CITY OF WESTMINSTER			
PLANNING APPLICATIONS COMMITTEE	Date 10 th October 2017	Classification For General Release	
Report of Director of Planning		Ward(s) involved West End	
Subject of Report	8 Chesterfield Hill, London, W1J 5BW,		
Proposal	Erection of a new residential building comprising 5 flats (Class C3)		
Agent	Jon Dingle		
On behalf of	Wellingtons Developments Ltd		
Registered Number	17/05737/FULL	Date amended/ completed	10 October 2017
Date Application Received	29 June 2017		
Historic Building Grade	Unlisted		
Conservation Area	Mayfair

1. Refuse planning consent - design

Proposed north elevation:

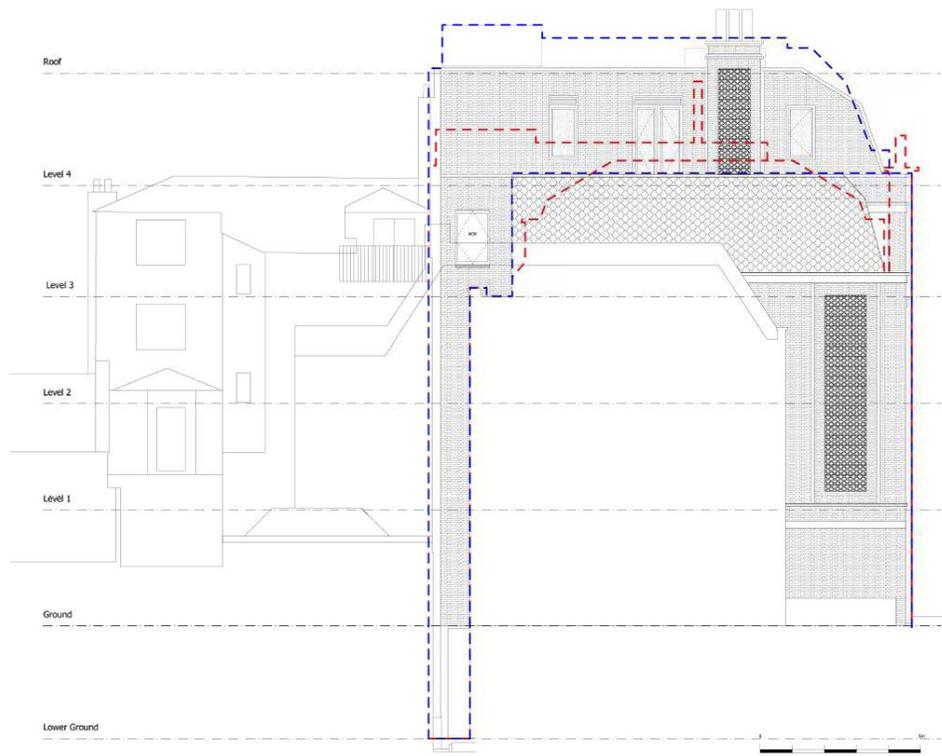
the conservation area and reinforces the sense of the building having a 'basemiddle-and-top'. This improves the appearance of the building in views along South Street and Chesterfield Hill. However, the modest overall height reduction and the off-centre dormer windows on the Chesterfield Hill façade are not considered to have addressed the previous reasons for refusal and are points noted by the Inspector in dismissing the appeal. Furthermore, the height of the building is noted, amongst other things, by the Inspector as causing harm to the setting of the Grade II listed pub in Farm Street, and the floor-to-ceiling windows to which he also objected are still present. The Inspector found that the modest benefits of the scheme did not outweigh the harm to heritage assets and it was a key part of the City Council's case that the same benefits could be delivered by the approved development without the harm.

Proposed
 North East Elevation

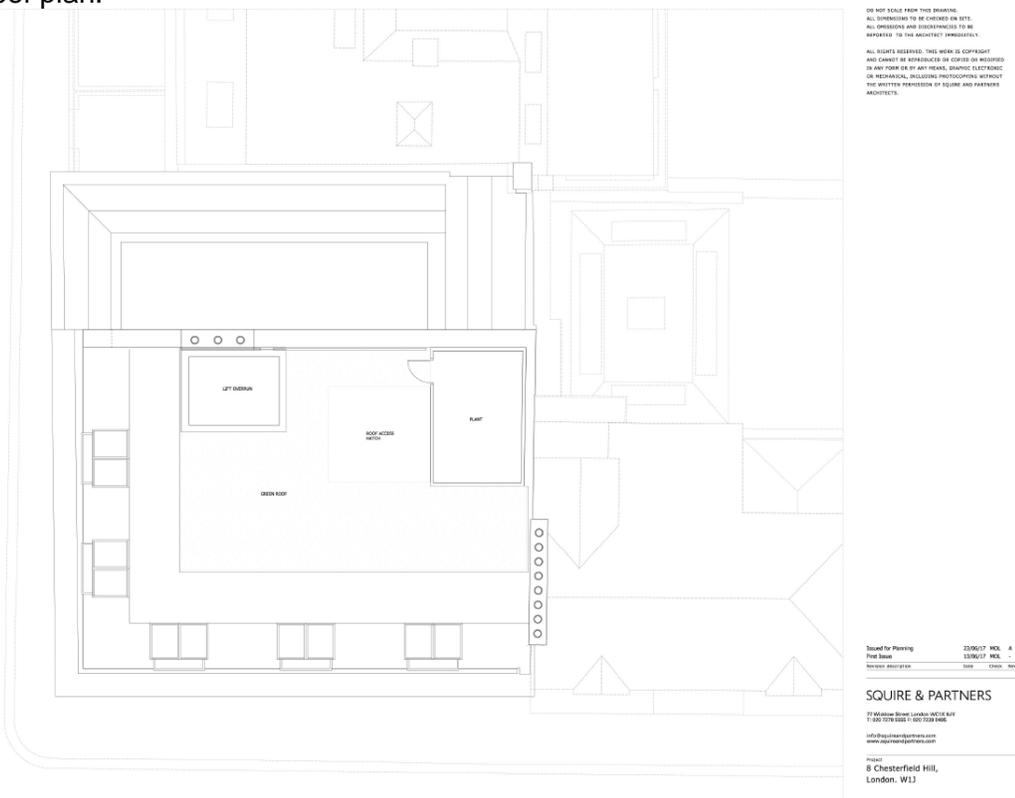
The adjoining occupier at 24 Farm Street has objected on the grounds of potential overlooking. The proposed scheme introduces one new east facing window at fourth floor level when compared with the 2016 refusal. This window serves a study, and whilst it would be positioned slightly forward of the front building line at Farm Street, it is considered that only very limited oblique views would be gained from this window and as such there would be no unacceptable loss of privacy to properties along Farm Street.
